January 7, 2026

Re: Comments and Hearing Request Regarding Lennar Homes of Texas and Jeanette R. Morris and Bobbie J. Neff Application for TPDES Permit No. WQ0016660001- Broken Cedar Ranch Wastewater Treatment Facility

Figure 1: Location of Groundwater Wells from Proposed Broken Cedar Ranch WWTF

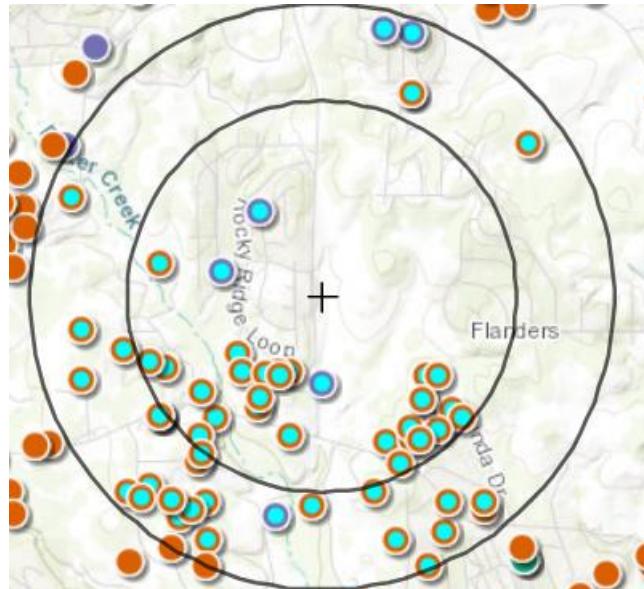
B. Impacts on Surrounding Groundwater Wells and Aquifer Protection: According to the Texas Water Development Board (TWDB), 63 water wells were found to be within a 1.5-mile distance of the Broken Cedar Ranch WWTF, with 32 wells found to be within a mile distance of the Broken Cedar Ranch WWTF (Figure 1). Water well data was pulled from three TWDB groundwater databases: TWDB Groundwater Database (GWDB) reporting 7 wells in the 1.5-mile distance area, Submitted Drillers Reports (SDR) Database reporting 56 wells in the 1.5-mile distance area, and Brackish Resources Aquifer Characterization System (BRACS) Database reporting 0 wells in the 1.5-mile distance area¹.

Further examining the stated water well data, 56 out of the 63 wells were noted to be used for domestic (household), irrigation, or public supply purposes. The volume of wells located in this close proximity to the facility, discharge point, and route poses a serious concern of cross-contamination with the local

groundwater supply that these well owners rely on to meet their needs. Many private wells are not subject to routine water quality monitoring, and well owners rely on groundwater as their primary source of drinking water. The intermittent nature of the receiving stream, combined with the density of nearby wells, raises concerns regarding potential groundwater vulnerability, particularly in areas where surface water may lose flow to the subsurface.

Additionally, GEAA notes that the application does not include a site-specific evaluation of groundwater connectivity, losing-stream conditions, or well vulnerability along the discharge route. GEAA requests that TCEQ carefully consider the proximity of groundwater resources and ensure that permit conditions adequately protect aquifer resources and private well users.
